NUREG-1135  
Supplement No. 1

# Safety Evaluation Report

related to the construction permit and  
operating license for the research reactor  
at The University of Texas

Docket No. 50-602

Figure 2.3

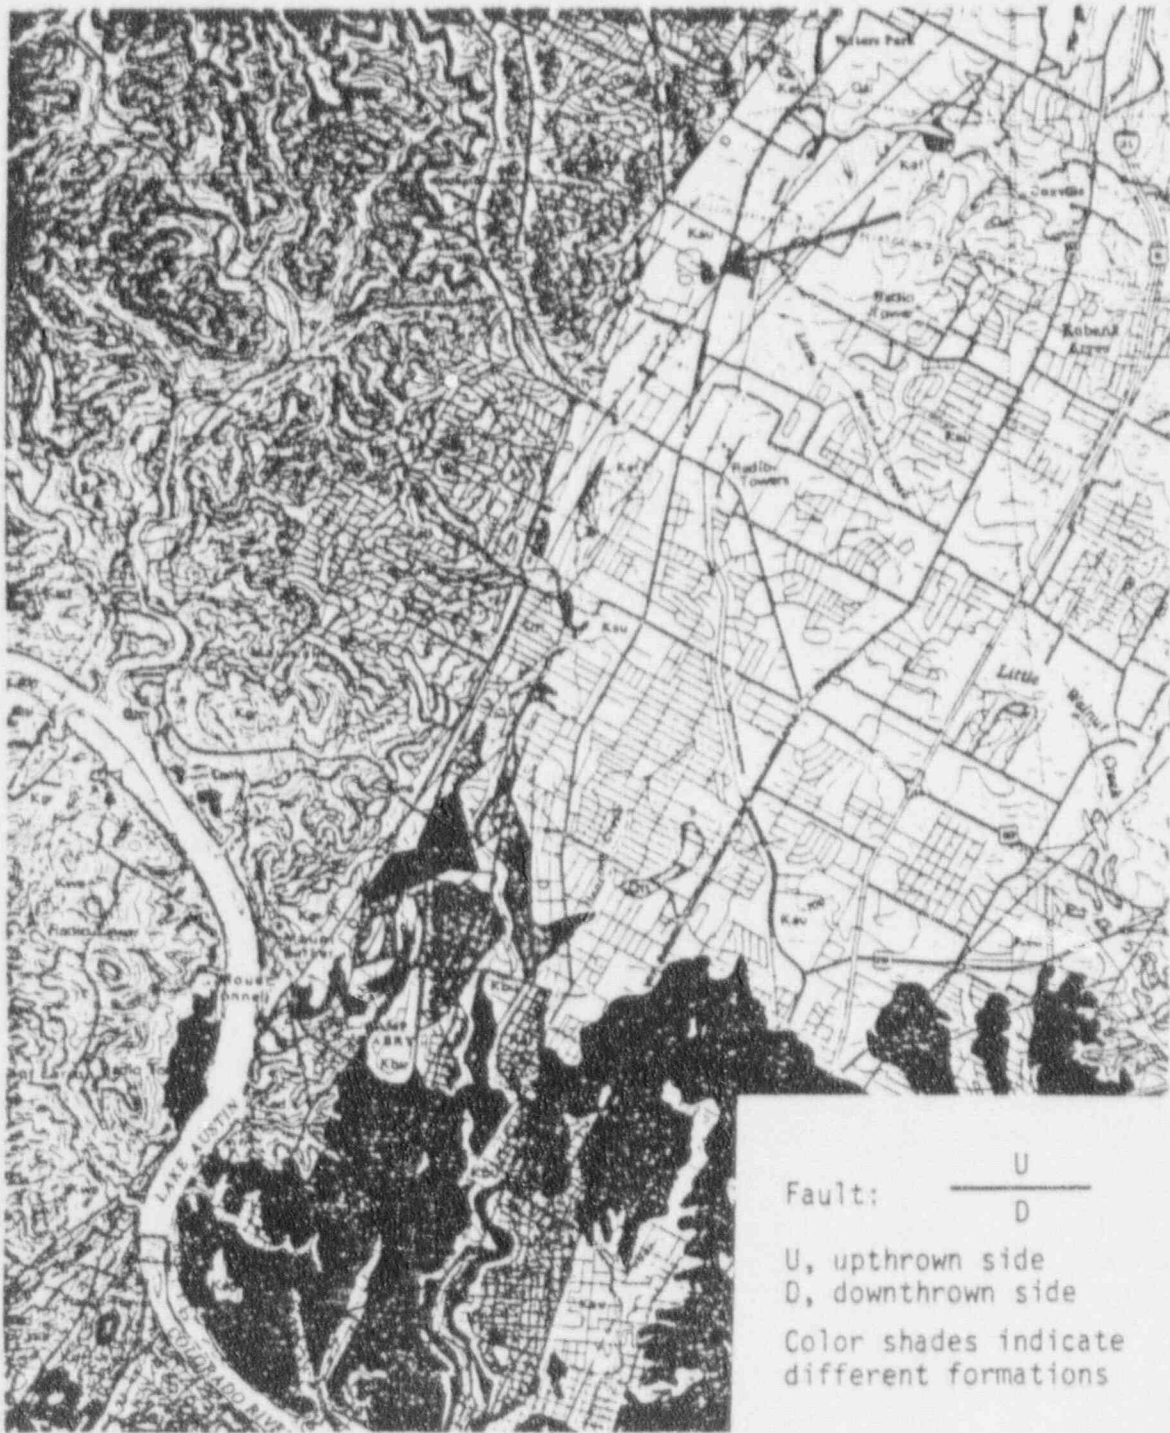
Replace Figure 2.3 with the revised figure. The revised figure shows the correct location of the Nuclear Engineering Teaching Laboratory (NETL).

Figure 3.1

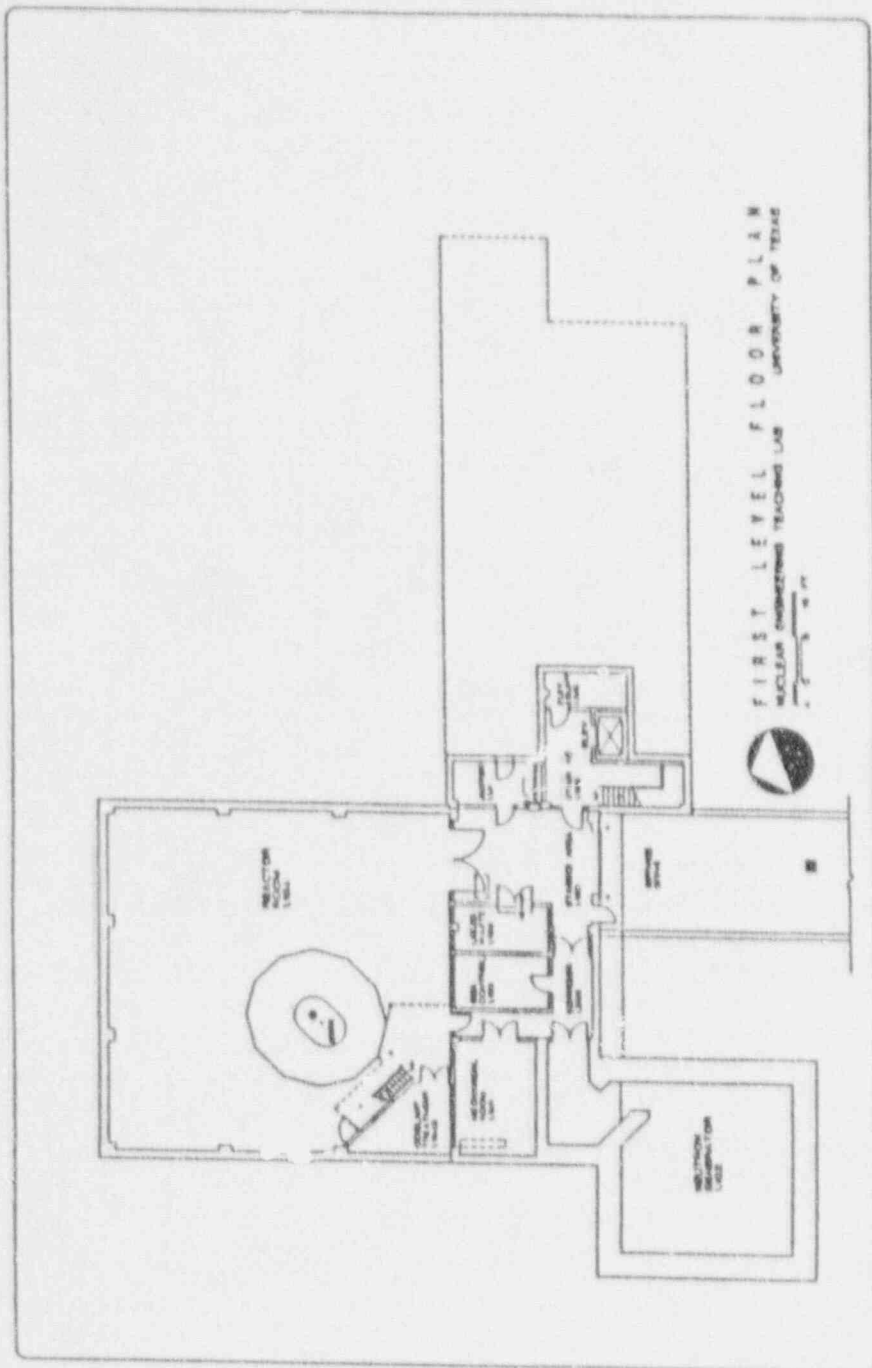
Replace Figures 3.1 to 3.4 with new Figures 3.1 to 3.6. These figures reflect the as-built facility. The changes in the facility are primarily limited to the location and orientation of rooms. The staff concludes that these changes do not affect the reactor safety analysis.

Figure 4.1

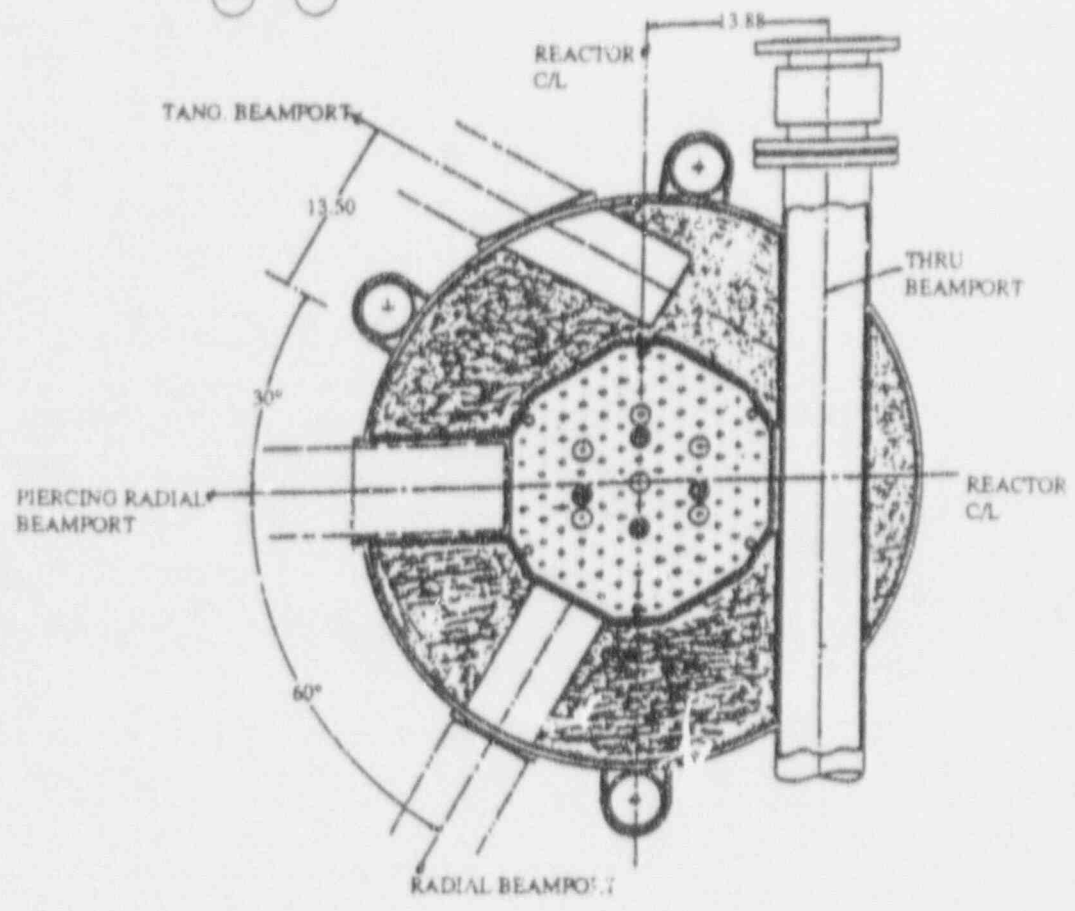
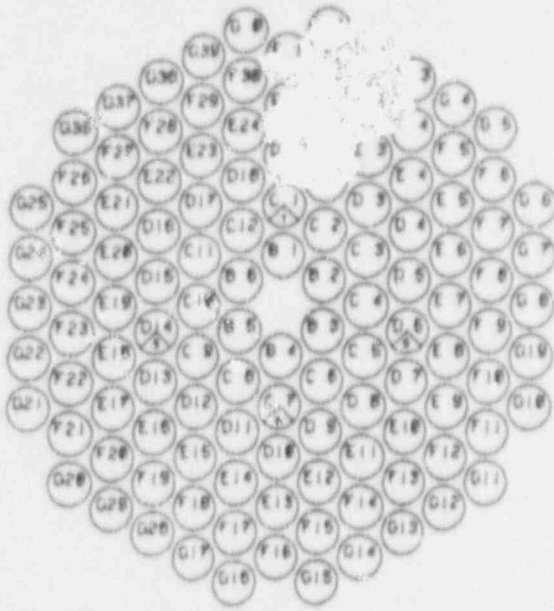
Replace the existing Figure 4.1 of a typical TRIGA Mark II reactor with the new Figure 4.1 which shows the UT TRIGA Mark II reactor.

Figure 4.3

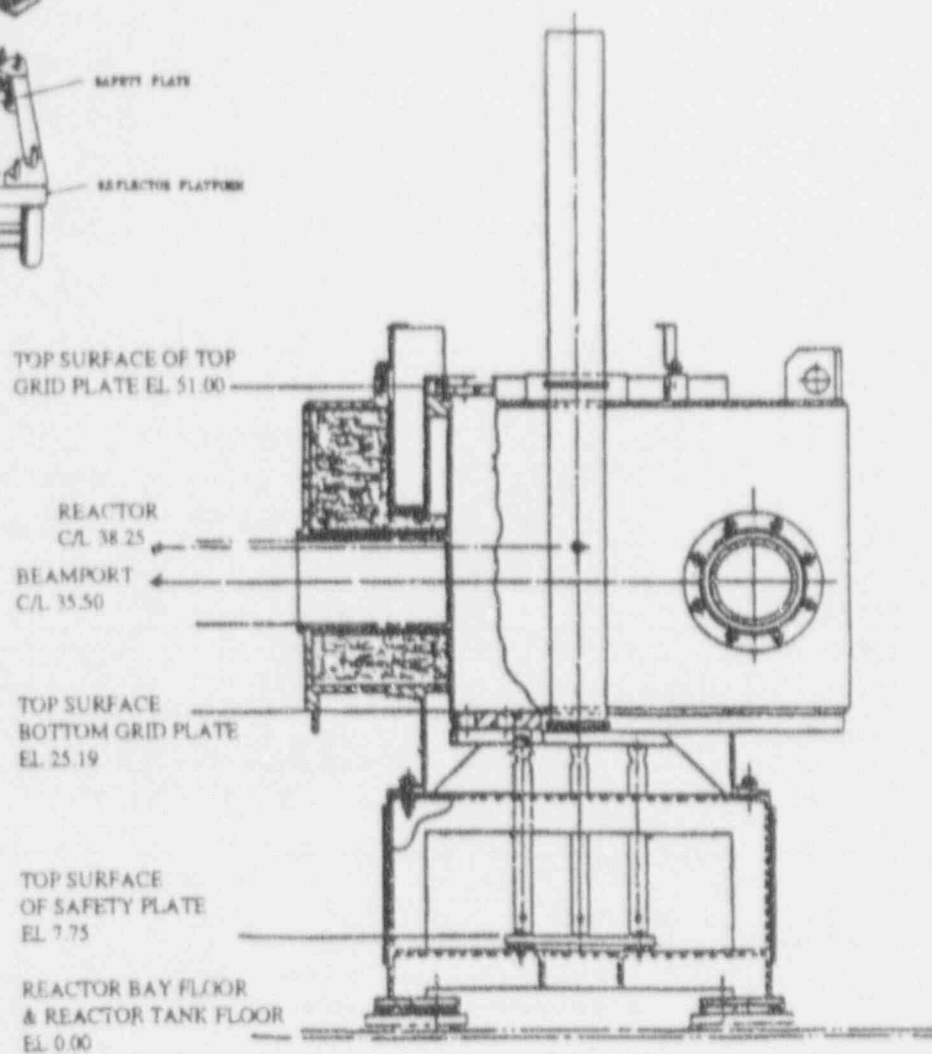
Replace Figure 4.3 which shows the core arrangement for the UT TRIGA reactor. The transient control rod is in location C-1, the shim rods are in locations D-6 and D-14, and the regulating rod is in location C-7.

Figure 5.1

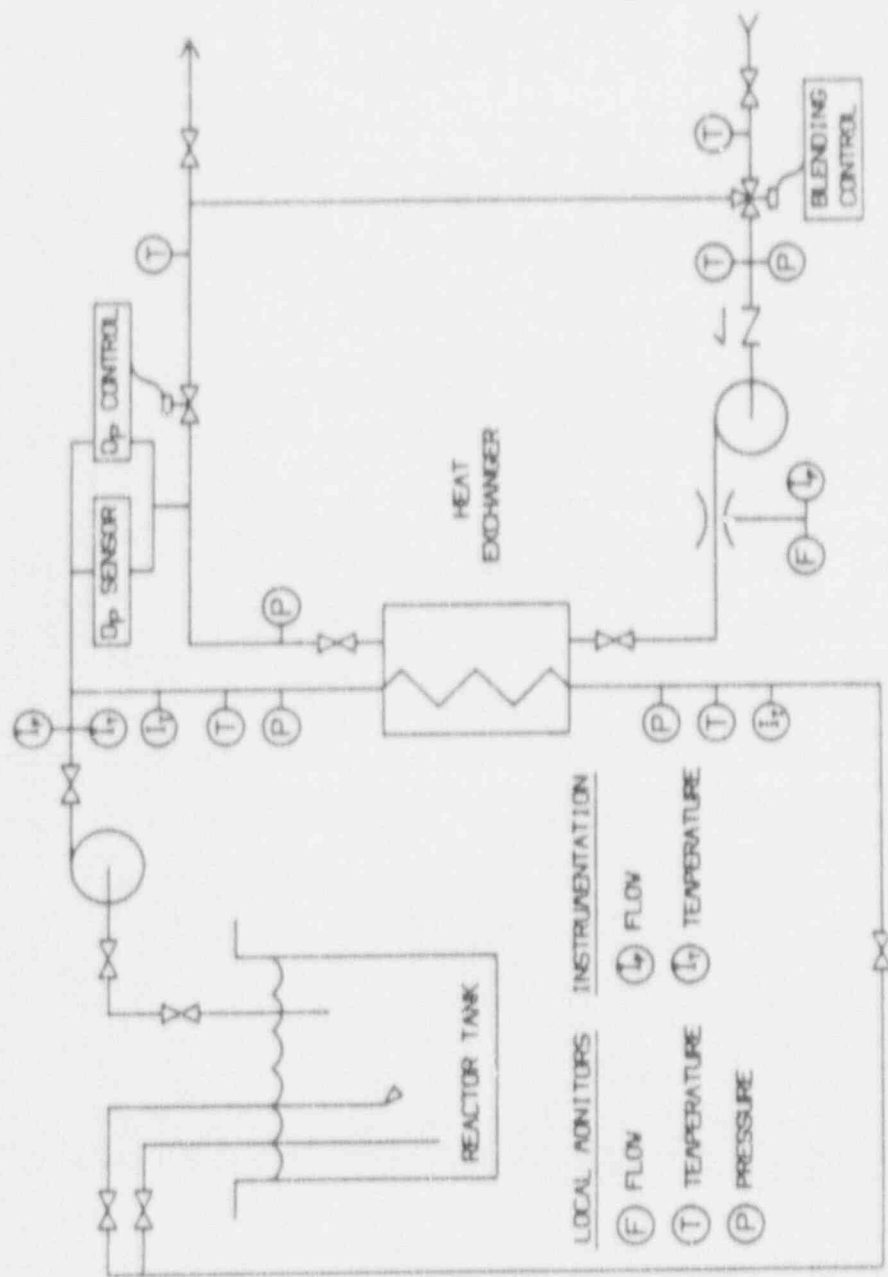
Revise Figure 5.1 and add Figure 5.2 to reflect the as-built reactor coolant and purification systems.

The SER discusses two cooling system suction intakes. The final reactor design includes only one suction intake for the reactor cooling system. The primary coolant purification system discussed in Section 5.2 provides the suction for water surface skimming.

A purification loop will be incorporated separate from the cooling system. Suction of water from the reactor pool for purification is provided by two inlets which extend no more than 6.5 feet (2 m) below the top of the reactor tank. Valves are used to select suction from either a surface skimmer or a subsurface inlet. The purification skid will be located at about the same vertical location as the heat exchanger. The purification loop pump will circulate continuously approximately 10 gallons per minute (0.6 l/s) of pool water to remove suspended particulates and soluble ions from the water coolant. Treated water is returned to the pool through a subsurface discharge pipe.

Figure 7.2

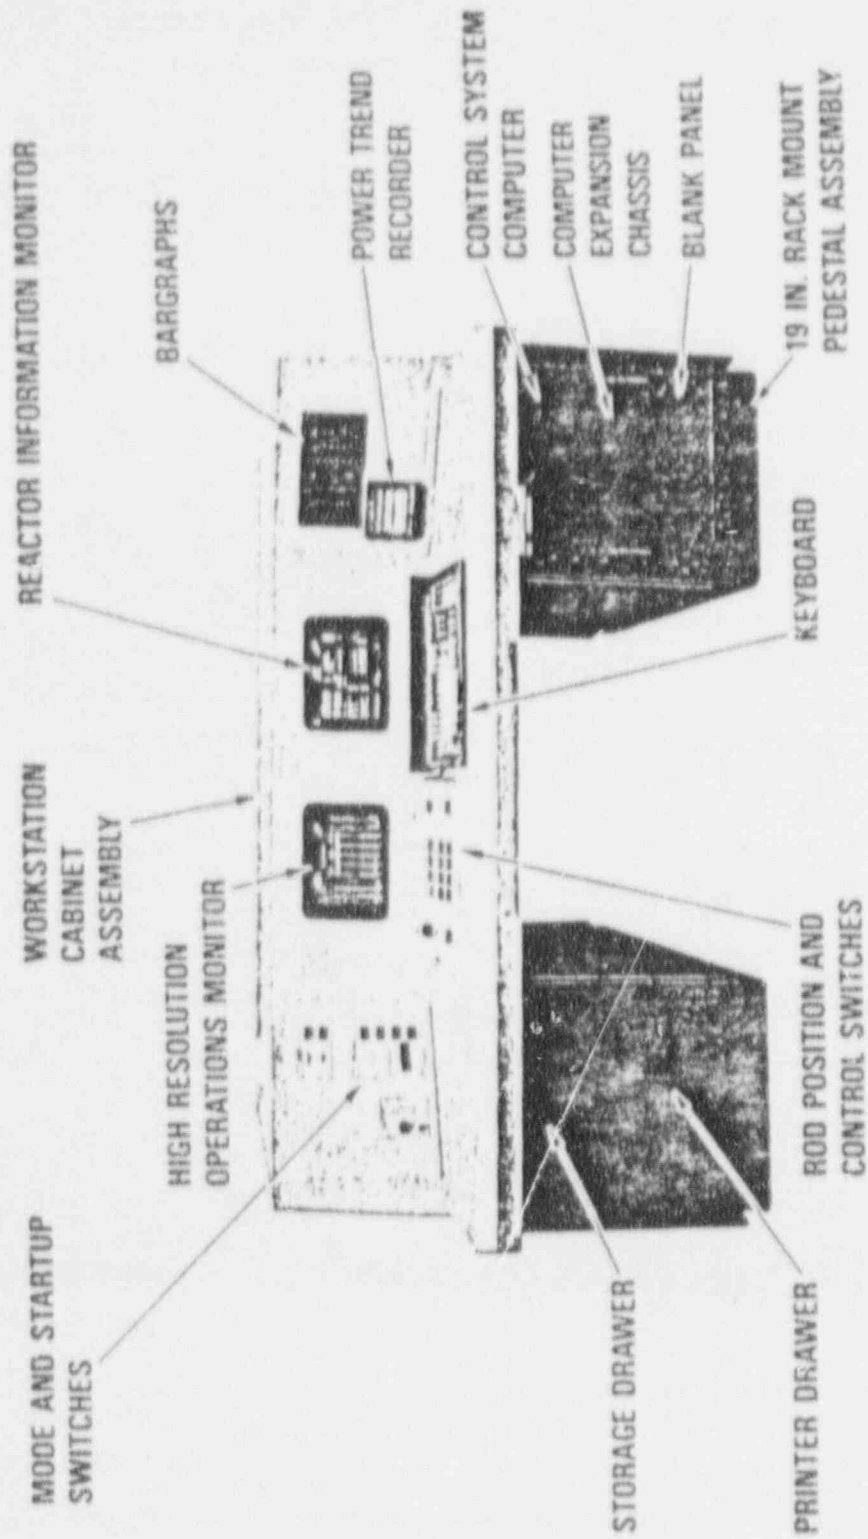
Figure 7.2 shows the final design of the control console and replaces Figure 7.2 in the original SER. The final I&C system does not have the two independent instrumentation computers discussed in the original SER. Figure 7.3 shows the final layout of the control panel which replaces the conceptual layout shown in Figure 7.3 in the original SER.

Figure 7.5

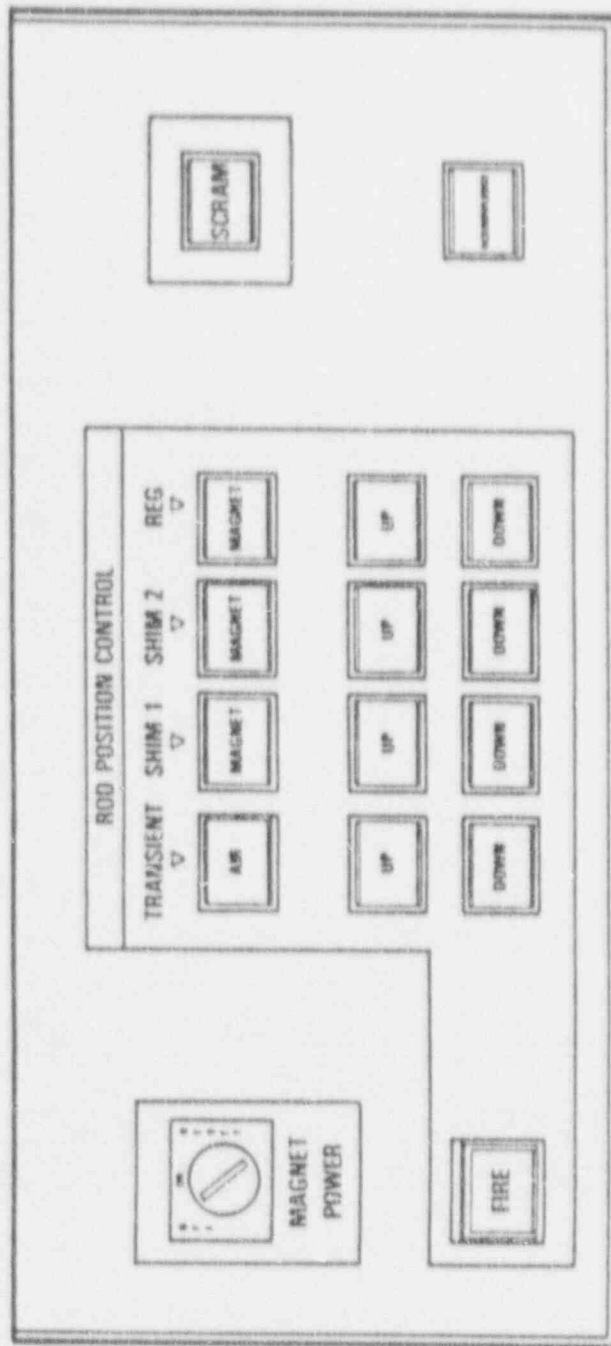
The "contact/on" (C/O) buttons have been renamed "magnet" (shim and regulating rods) or "AIR" (transient rod) push buttons. Their function remains to interrupt current to the shim or regulating rod magnets or to the transient rod air supply solenoid valve. The new Figure 7.5 shows the rod control panel.
